I have the honour to state that the -----
registered occupant of survey No. 3A, 3A, 3A (Sheet E.5.)
+ 9444 *garden* Quarter, has applied for permission to
build in accordance with the attached plan, and to inquire
whether you have any objection from a municipal or -----
sanitary point of view to the proposed building.

NOTICE UNDER SECTION 96 OF ACT III OF 1901.

I beg to inform you that I intend building a godown in
place of existing servants quarters on plot No. 3A.A/A₂
Survey Sheet No. E.S. Situate in Lawrence Road
Garden Quarter.

ELEVATION

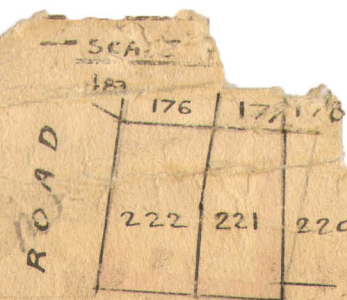
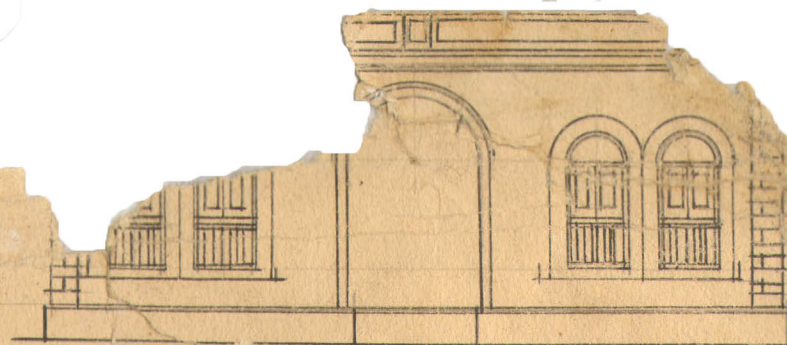
Inform applicant that
 the plot is too crowded to
 allow for the proposed
 building being erected.
~~Also~~ a portion of the
 plot will have to be re-
 linquished when the Lawrence
 P. Improvement Scheme
 is carried out which
 will further diminish the
 area of the plot.

Enquiry officer
 please attach
 F.C. There was no
 correspondence &
 permission was not
 granted owing to
 the over crowding.

F.C. attached &
 beg to report that the
 plot will be overcrowded
 & the portion of it comes
 within the Lawrence Road
 scheme -

Shew up with Lawrence Rd
 improvement plan
